Technical Service Bulletin: TSB110077

Released Date: 23-Mar-2011

New C-Series Connecting Rod Assembly

New C-Series Connecting Rod Improvements

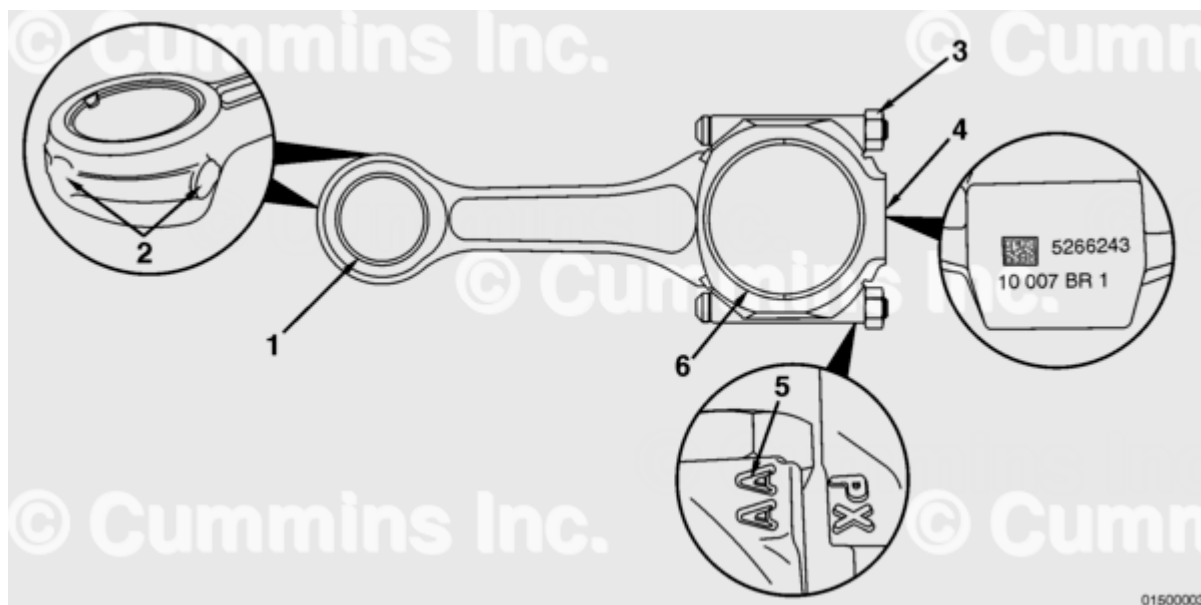
The design for the new rod is very similar to the present C Series connecting rod, but a new part number was needed, due to slight differences in appearance and to improve traceability. The new connecting rod assembly, Part Number 5266243, is very similar to the present connecting rod assembly, Part Number 4947898.

The most notable difference in the new connecting rod, compared to the present C Series connecting rod, is the addition of a thermal installation process for the connecting rod small end bushing. This process is used by the supplier for the B and L connecting rods, and is expected to significantly improve small end bushing contact.

Along with the introduction of this new connecting rod assembly, all C Series connecting rods will have an increase in final torque angle from 60 degrees to 90 degrees, yielding a higher clamping force.

1. Thermal assist bushing installation (**not** serviceable).
2. Machined reference pads.
3. New nut supplier (same source for rod bolt and bushing).
4. Part number barcode added.
5. Heat code changed from raised to low relief.
6. Machined split design (same as present part).

The new connecting rod assembly, Part Number 5266243, and the present connecting rod assembly, Part Number 4947898, are interchangeable and may be mixed in the same engine. Service will use a single cylinder replacement strategy for these new connecting rods.
